Addendum No. 1

Date: March 1, 2017

Project: **E.I.F.S. & HVAC**
Longview Readiness Center
Project Number 2016-639
Longview, WA

SHEET NO.
M2

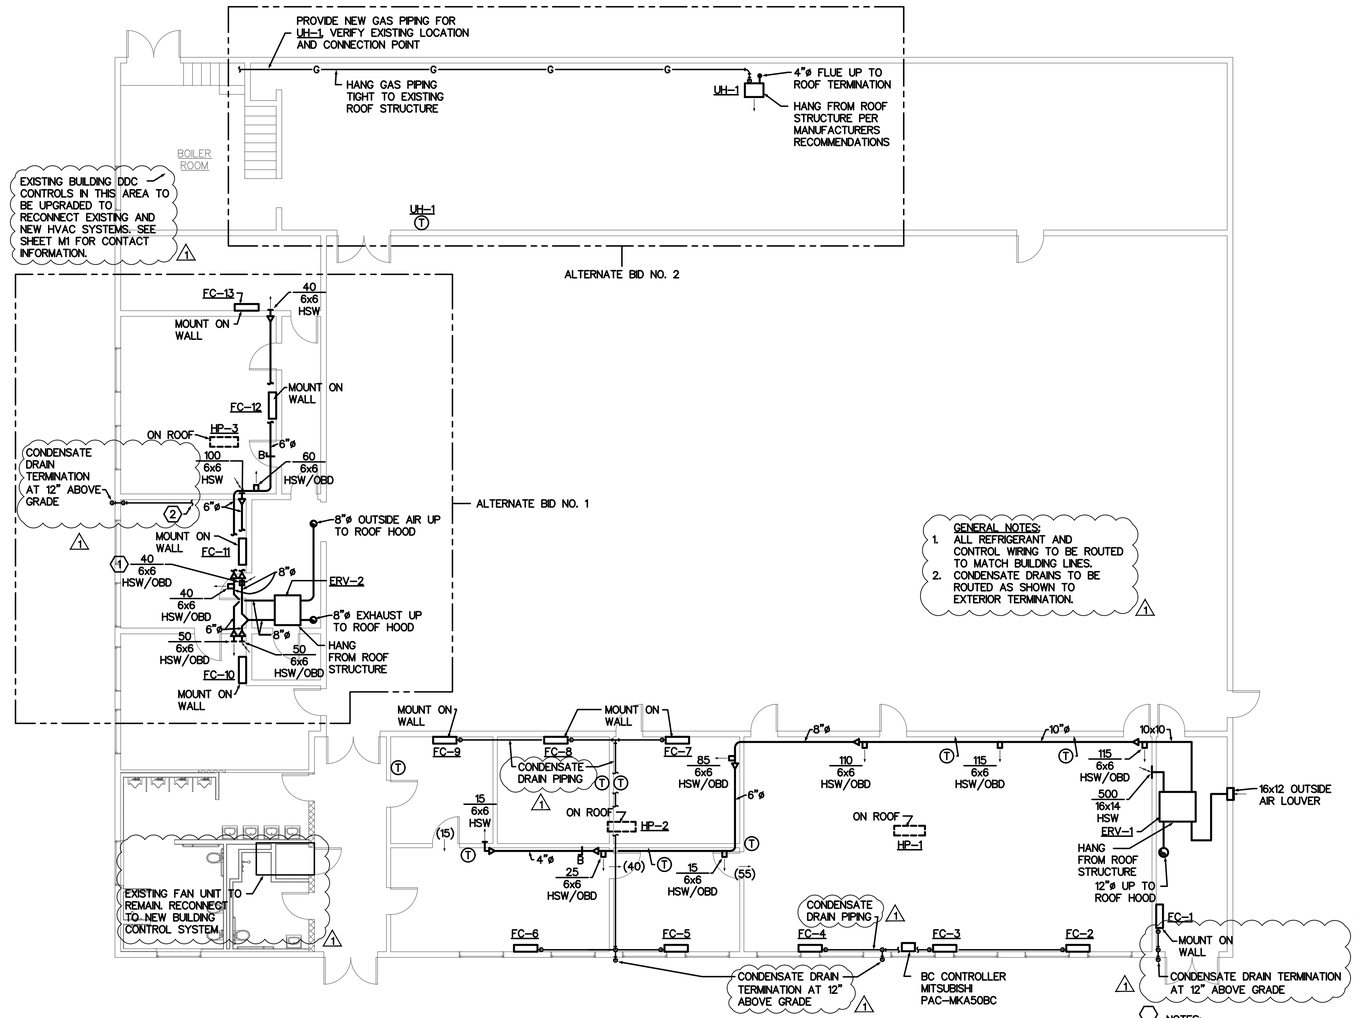
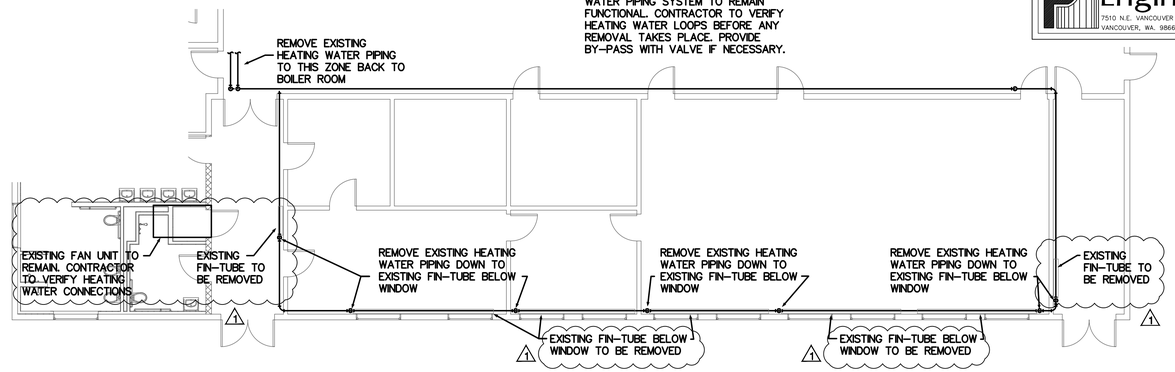
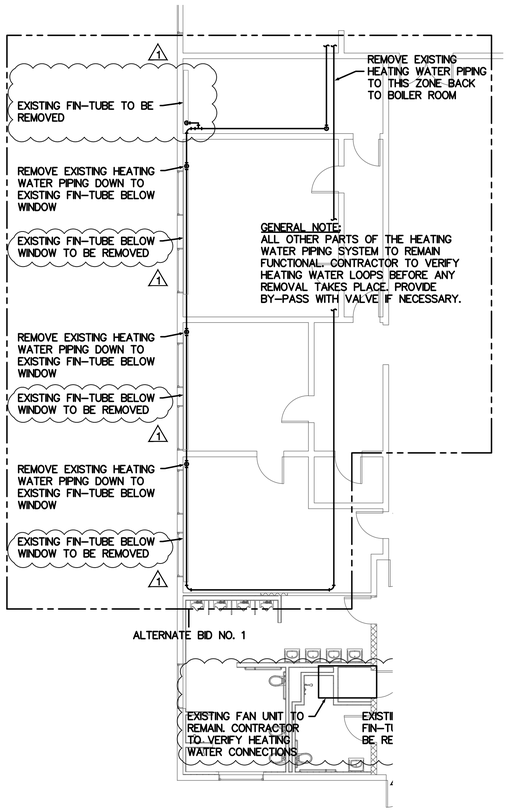
1.4	M2	See attached revised sheet M2 which has the following changes: 1. Added building DDC control locations (Boiler Room) 2. Changed demolition plans to reflect the removal of the existing fin-tube at all locations of new HVAC installation. 3. Added existing heating fan unit at bathroom location to remain and be reconnected to updated control system. 4. Added condensate drain routing from FC's to exterior wall terminations.
